Re: John R. Pierce School Project  
Designer Services Contract Amendment No. 16

**AMENDMENT NO. 16**

**WHEREAS**, the scope of this work is summarized in the attached Miller Dyer Spears (MDS) Additional Services Request Proposal for Unforeseen Conditions at Historic Building Columns, dated May 2, 2025.

Re: Pierce School - Additional Historic Building Columns

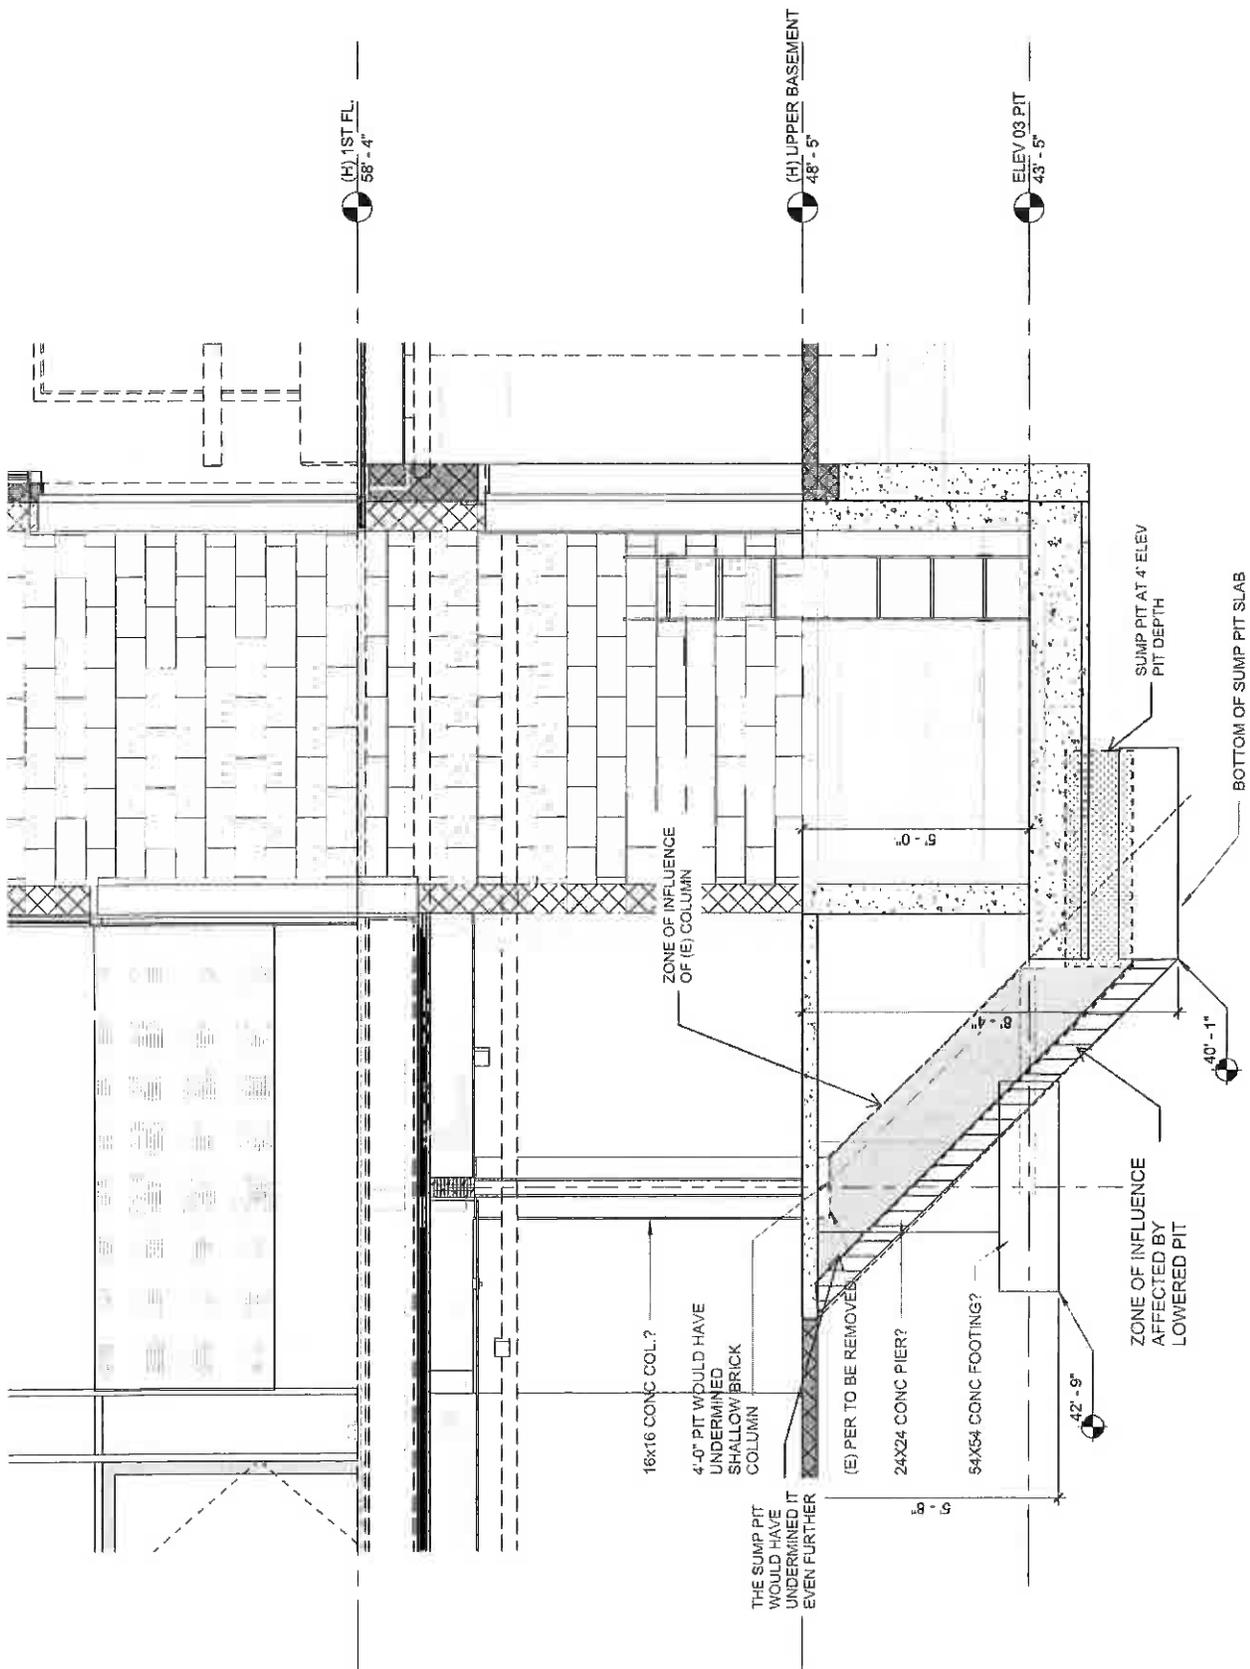
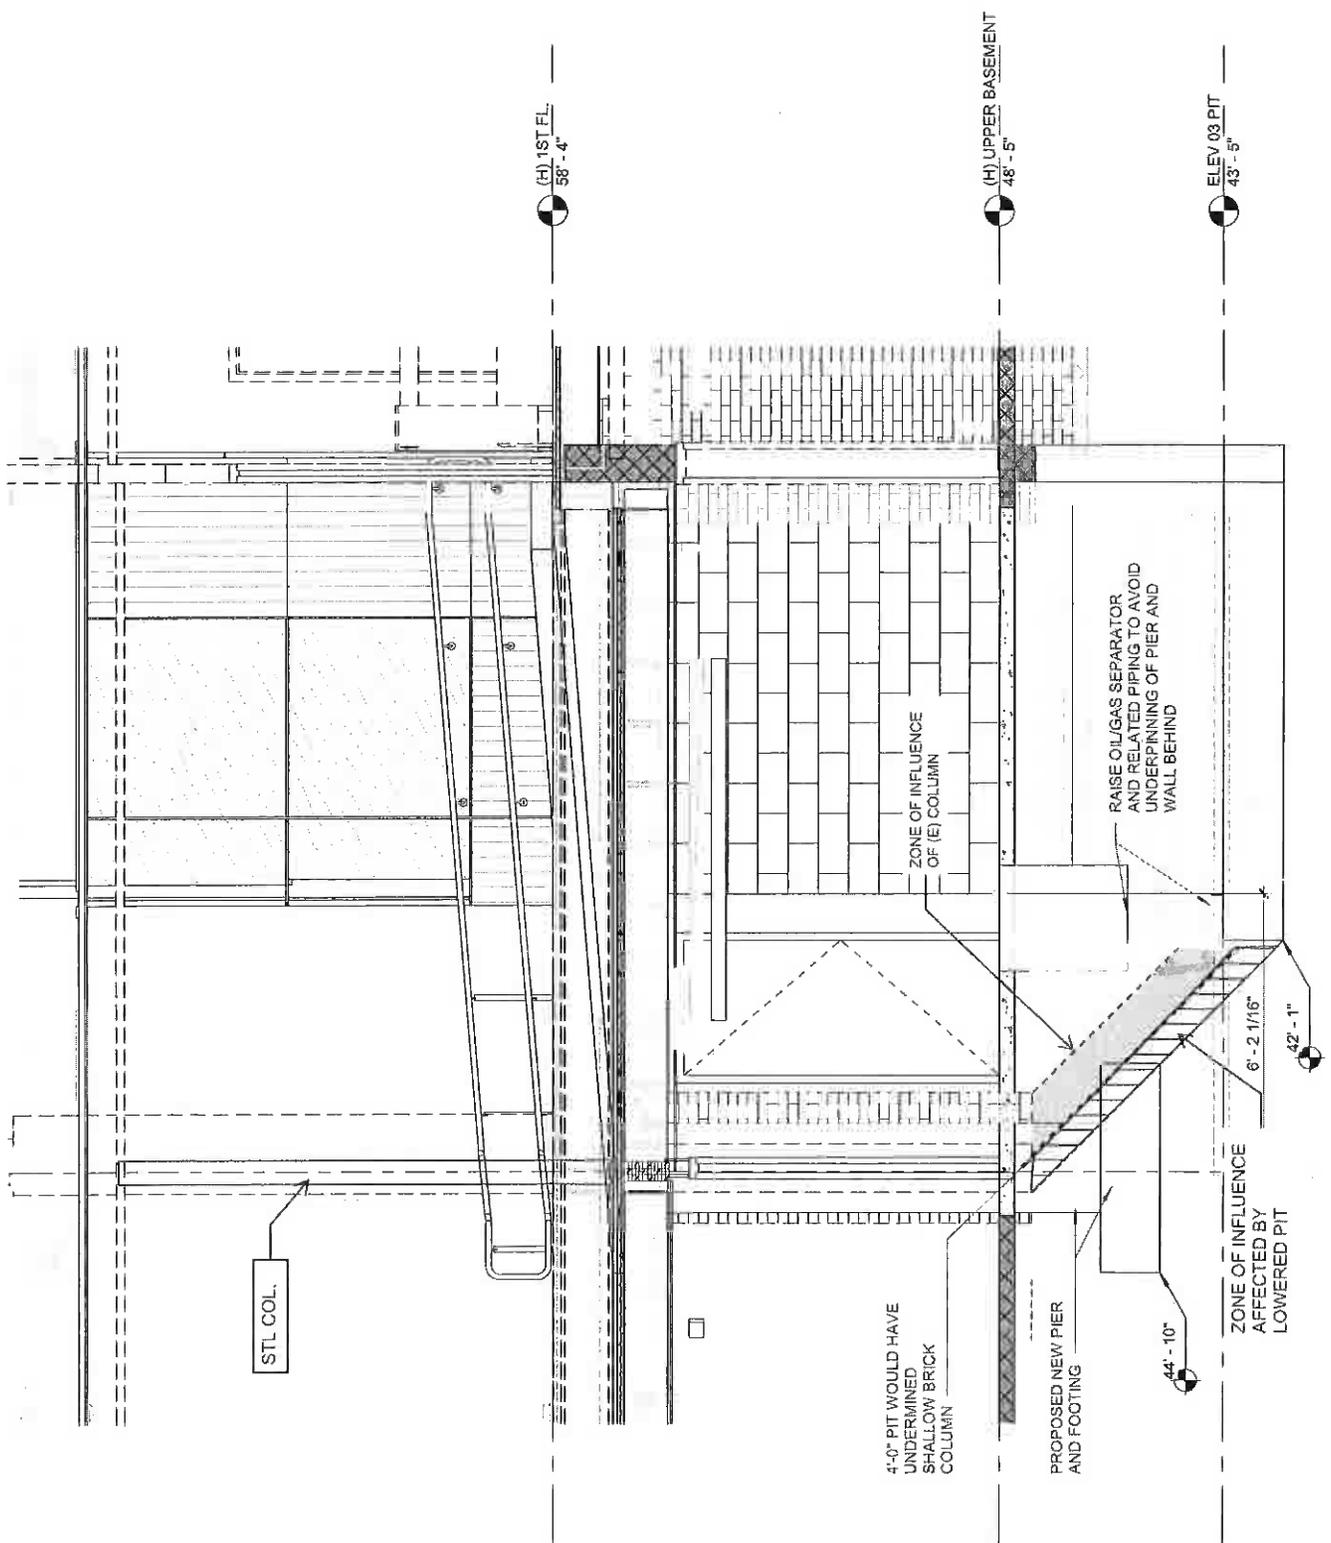
The existing columns were found to only extend +-9 inches below the existing slab, which was significantly shallower than expected.

- Either added underpinning or replacement of the three existing brick columns would be required.
- As the lowering of the 1<sup>st</sup> floor was already removing a portion of the three columns, it was determined that replacement was the best solution. These new columns will also accommodate the proposed lower elevator pit.
- See section sketches attached.

Though, Consigli recently dug test pits at the existing columns and the bottoms are only at +-47.7', so the 4'-0" pit and especially the sump pit would have undermined the brick piers anyway.

Assuming it goes forward, Consigli would like to go with concrete columns. I suggest two at the intersections of the intersections of the LVLs, if that works for you all.

Frank and I discussed possibly 16x16 at the 1 story column and 24x24 at the one that connects to the steel column above. This would adjust the still column left to that intersection.

I've taken a pass at putting that in our historic building Revit model. See sections attached. I've also marked it on the structural drawings in the bluebeam session.

RAISE OIL/GAS SEPARATOR  
AND RELATED PIPING TO AVOID  
UNDERPINNING OF PIER AND  
WALL BEHIND

4'-0" PIT WOULD HAVE  
UNDERMINED  
SHALLOW BRICK  
COLUMN

PROPOSED NEW PIER  
AND FOOTING

ZONE OF INFLUENCE  
AFFECTED BY  
LOWERED PIT
